# SERVICE BULLETIN

Equipment: MW-5 AM Transmitter

Bulletin No. AM-091-KDL

## "REMOTE CONTROL MODIFICATION INFORMATION"

1A2A2 FLAG AND OVERLOAD

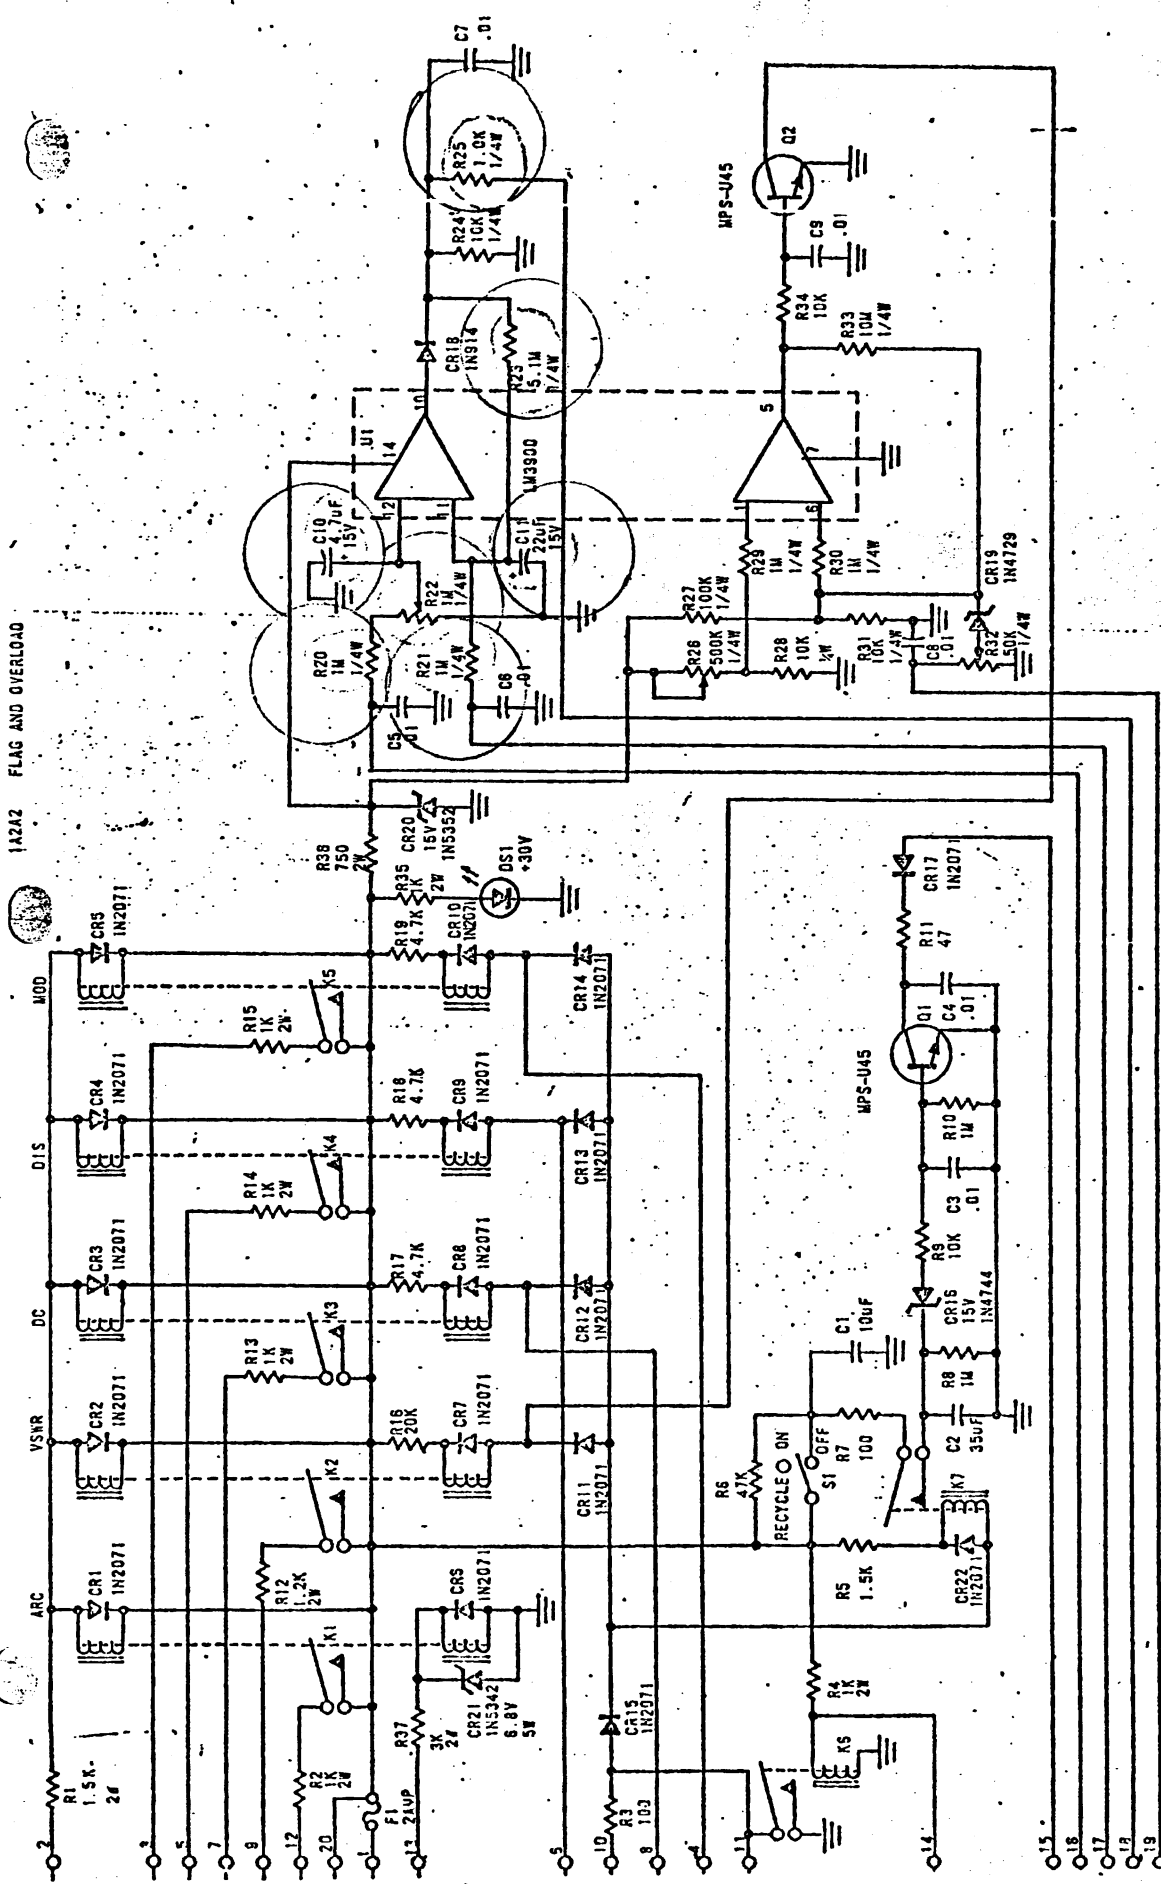
All changes are made on the flag and overload board, 1A2A2. Refer to the attached drawing for specifics.

1) Change resistors as follows:

<u>RESISTOR</u>	<u>OLD</u>	<u>NEW</u>	<u>PART NUMBER</u>	<u>PRICE</u>
R20, R21	10M	1M 1/4W 5%	540-0984-000	\$ .28 ea.
R23	10M	5.1M 1/4W 5%	540-1001-000	.28 ea.
R22	10M	1M 1/4W POT	540-0888-000	5.00 ea.
R25	10K	1K 1/4W 5%	540-0912-000	.28 ea.

2) Add capacitors as shown on the drawing: C10, 4.7 uf/15V from the wiper of R22 (changed per above) to common; C11, 22 uf/15V from Pin 11 of U1 to common. These capacitors improve circuit stability and minimize random remote meter fluctuations. Try to keep lead lengths short and neatly dressed.

<u>CAPACITOR</u>	<u>VALUE</u>	<u>PART NUMBER</u>	<u>PRICE</u>
C10	4.7 uf/15V	526-0040-000	\$ .90 ea.
C11	22 uf/15V	526-0313-000	1.25 ea.

R22 should be initially set to minimum and increased until the proper sensor voltage (sufficient for driving the remote control system) is obtained.

Please mark your instruction book schematic diagrams and parts lists to reflect these changes. All changes are circled in RED on the attached drawing. A copy of the revised 1A2A2 flag and overload board schematic to scale, is also enclosed for you to tape into your instruction book if you so desire.
